Re: Site Plan Review
Oak Hill Cemetery – Community Mausoleum
140 North Highland Avenue
NYK 0176

I offer the following review comments of the re-submission.

Sheet Number:
C-1.1

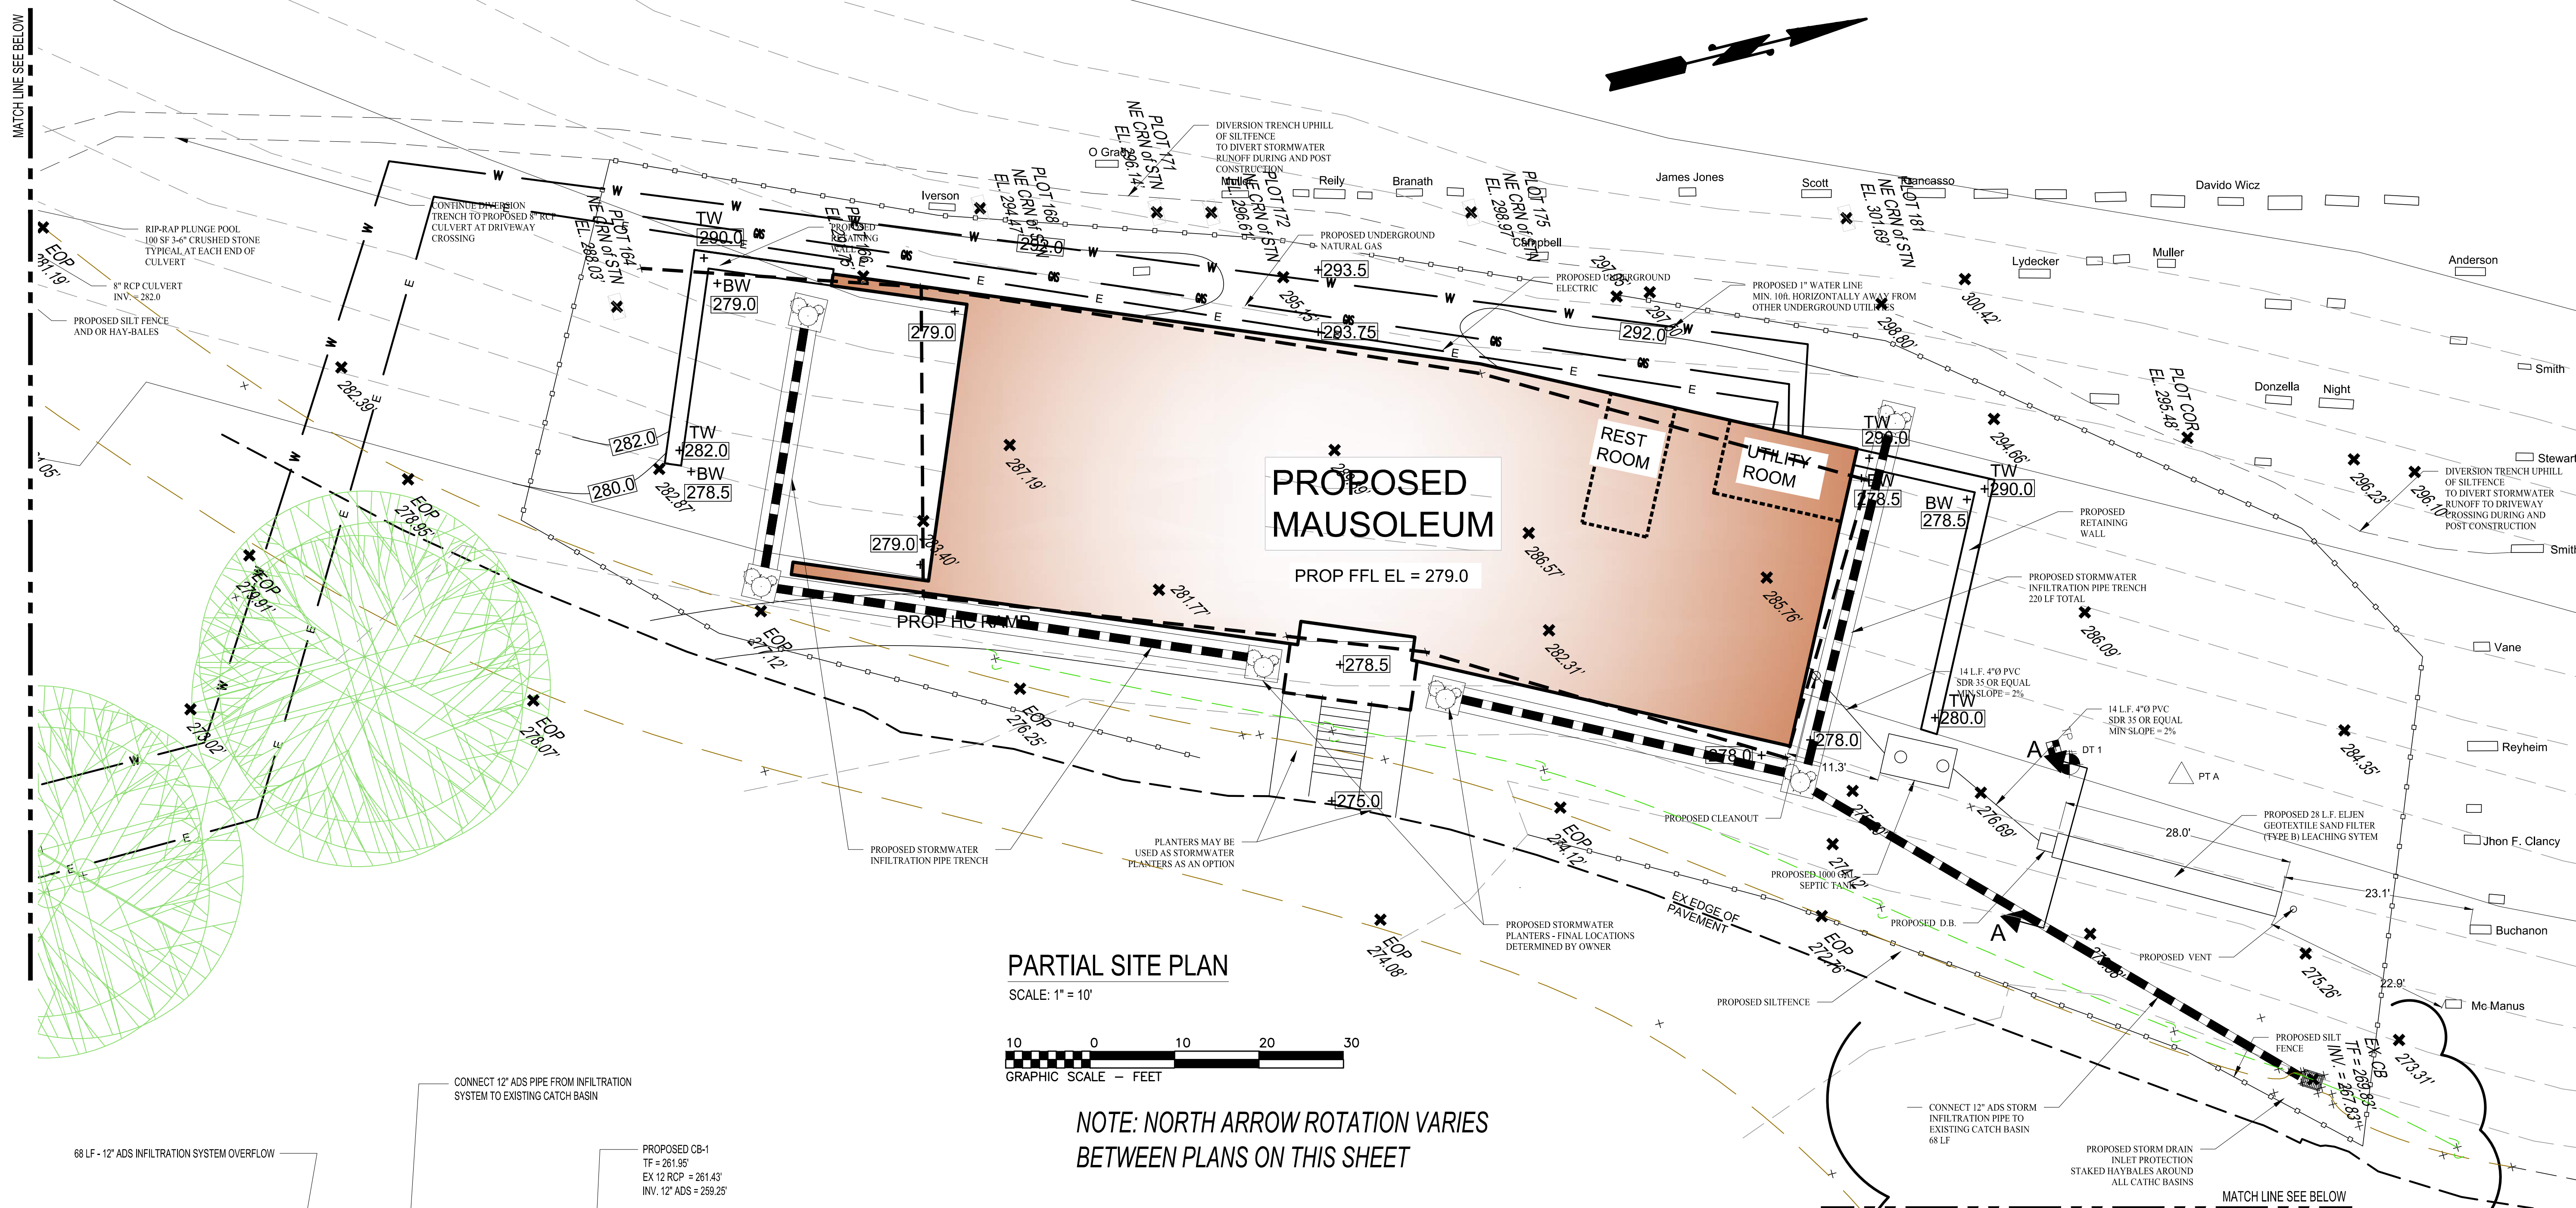
5. Rims and inverts should be added for catch basins, stormwater planters, diversion swale and infiltration trench. *Acknowledged, please see sheet C-1.1 Partial Site Plan Drainage and Grading for Rims and inverts provided. Additional Elevations and Proposed Finished Grade spot elevation will be provided .*

13. Though it is helpful to include a plan with aerial photography, the basis of the design of a site plan shall be a topographic survey with 2-foot contours. This topographic information is readily available through the Rockland County Planning. The source and datum of the topographic information shall be provided. Sheet C-3.2 is noted as the Mausoleum Grading Plan but existing topographic information and proposed grading is not clearly shown. A Grading Plan shall be developed clearly presenting existing topography, contour lines and proposed grades.

Noted: See Sheet C-1.1 for 2 foot contour intervals at disturbed areas, as well as spot elevations from field survey. This writer determined that the exercise of providing 2 ft. contour interval for the entire site was unnecessary since the disturbance is only a fraction (0.8 acres) of the total lot (38 acres)
